FirstEnergy Nuclear Operating Company

Beaver Valley Power Station, Unit No. 1  
Docket No. 50-334, License No. DPR-66  
Completion of Required Action by NRC Order EA-12-051, Reliable Spent Fuel Pool Instrumentation (TAC No. MF0799)

NRC Requests for Information  
Page 1 of 39

**NOTES:**

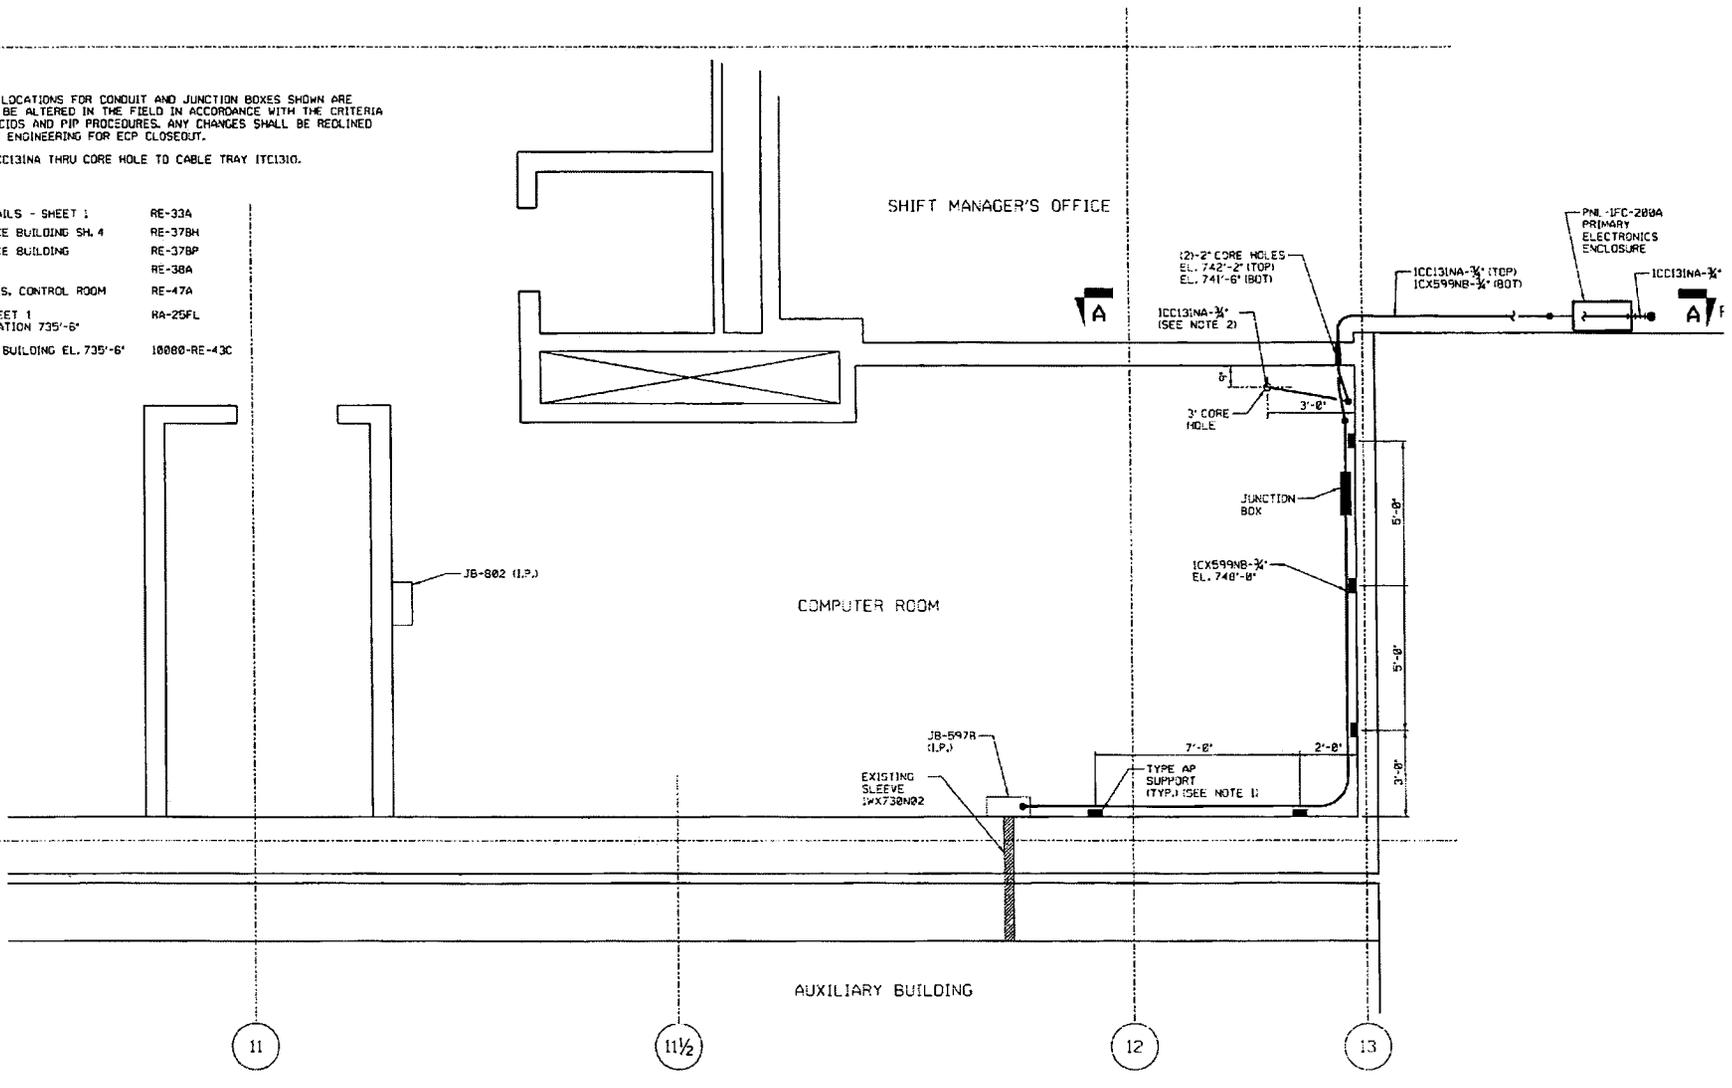
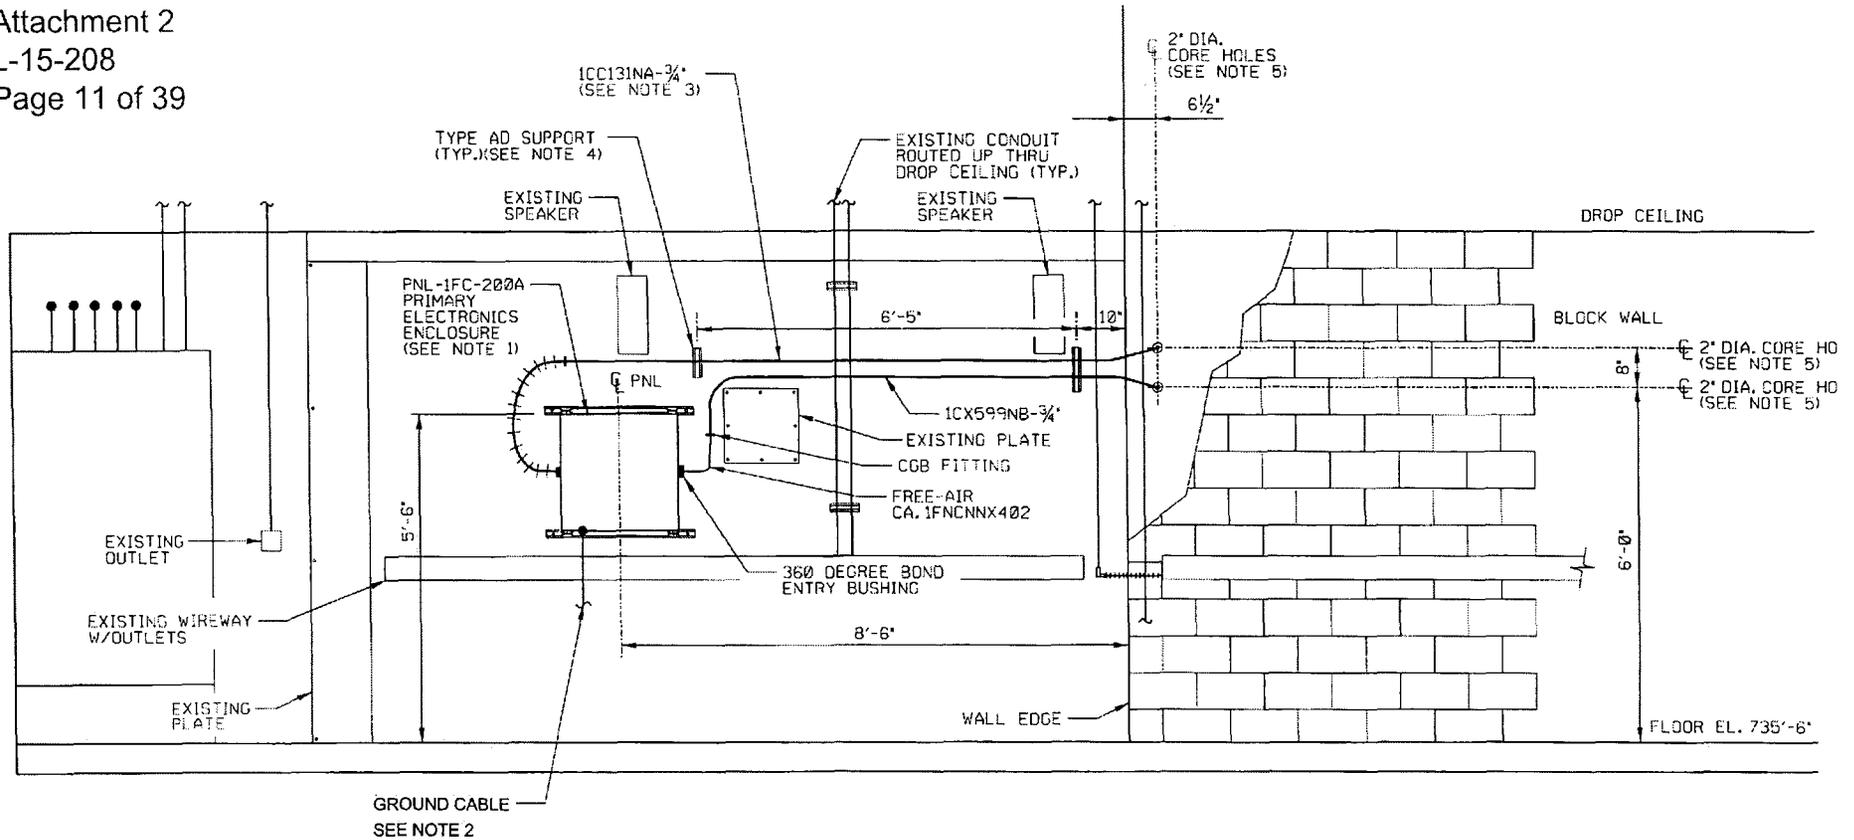
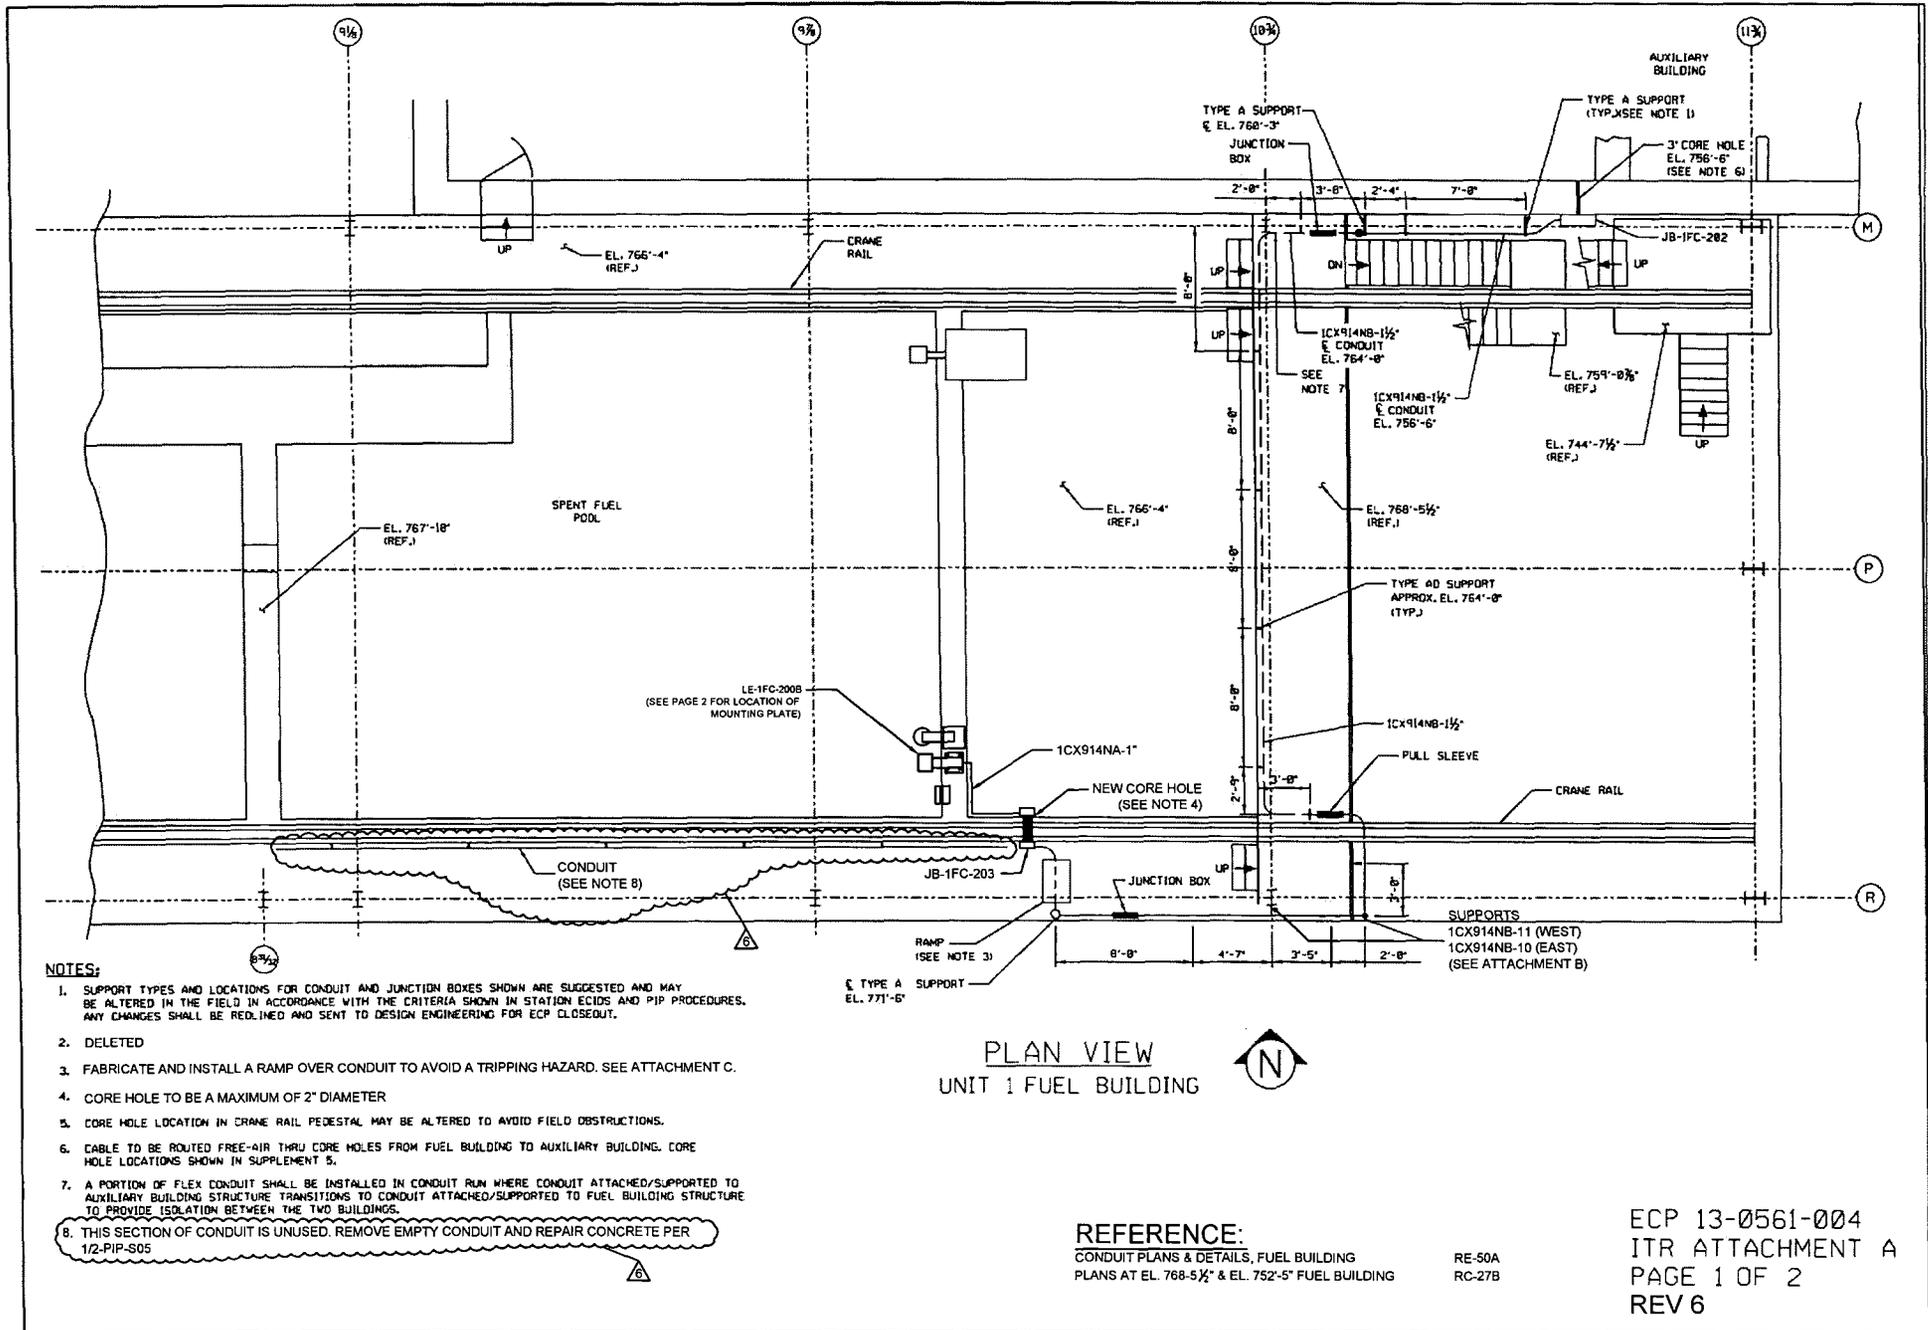
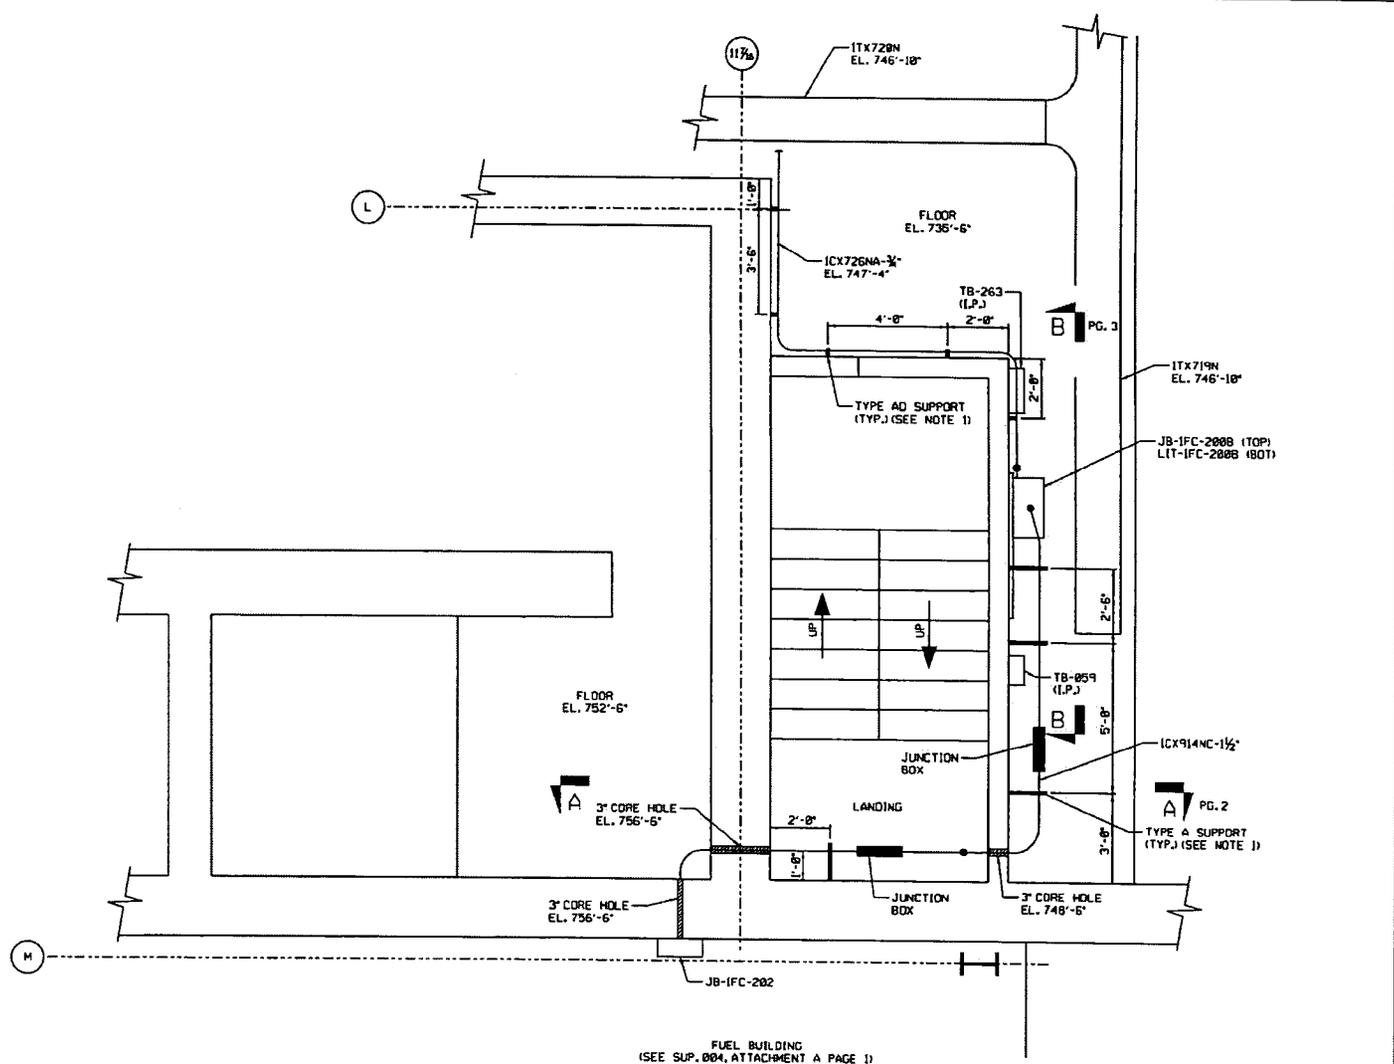
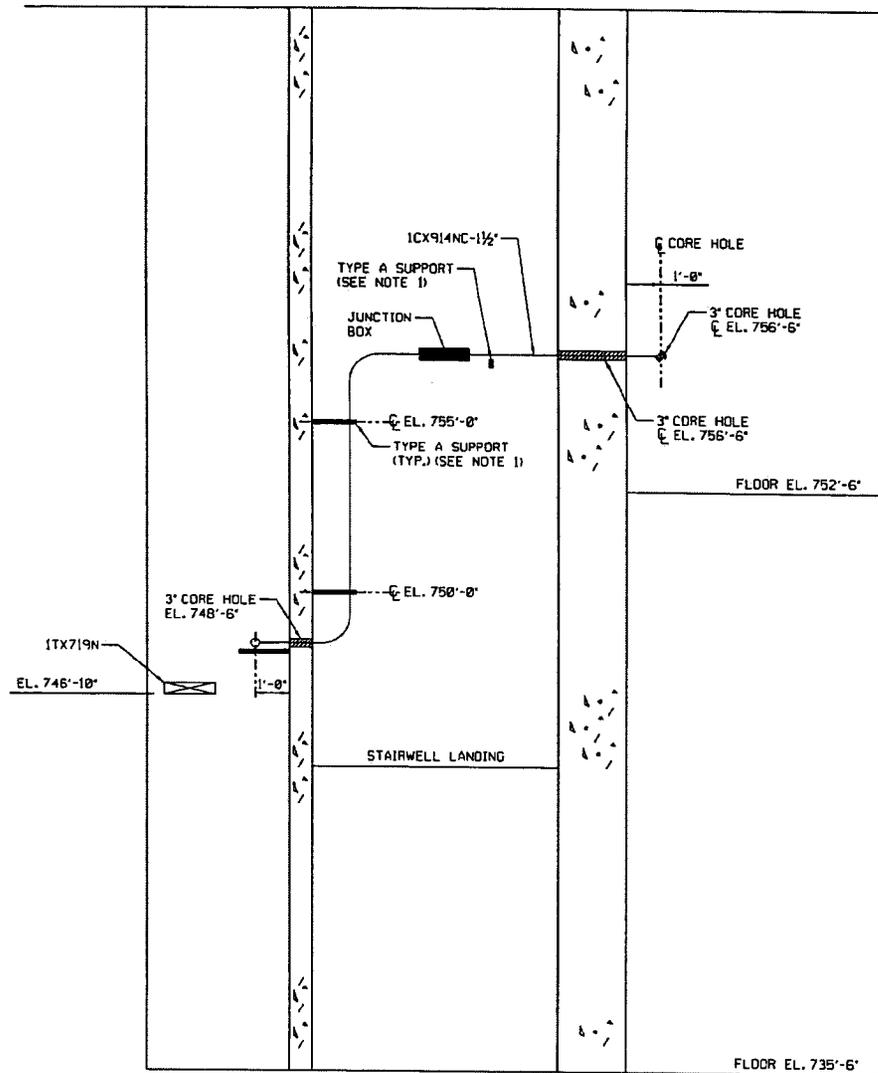
**Please provide a clearly labeled sketch or marked-up plant drawing of the plan view of the SFP [spent fuel pool] area, depicting the SFP inside dimensions, the planned locations/placement of the primary and back-up SFP level sensor, and the proposed routing of the cables that will extend from these sensors toward the location of the read-out/display device.**

The response to this RAI was provided by FENOC letter dated February 27, 2014. Subsequently, by FENOC letter dated February 26, 2015, the design for BVPS-1 progressed from conceptual design to final design. As a result, some of the locations of the instrumentation and conduit routing were changed. Updated sketches are provided below, depicting general configuration. Previous versions of these sketches were made available to the NRC staff for review.

The electronics enclosure units (transmitters) are located in an area removed from the SFP environment, which would be accessible in the event of a beyond-design-basis external event (BDBEE) that would restrict access to the SFP. The enclosures for the two instrument channels are separated to minimize the possibility of a single event damaging both channels. The primary level indicating transmitter LIT-1FC-200A is located on the west wall of the auxiliary building, general area elevation (El.) 735' 6", just east of the stairwell. The backup level indicating transmitter LIT-1FC-200B is located on the west wall of the auxiliary building, general area El. 735' 6", just east of the stairwell. The level transmitters located in the auxiliary building have a local display, although the credited display units will be located in the main control room (MCR). Cabling for each channel is run in separate conduits and cable trays to the control room indicators.

The primary electronics enclosure PNL-1FC-200A (control room analog indication) is located on the south wall of the old Shift Manager's Office in the control room, El. 735' 6". The backup electronics enclosure PNL-1FC-200B is also located on the south wall of the old Shift Manager's Office in the control room, El. 735' 6".
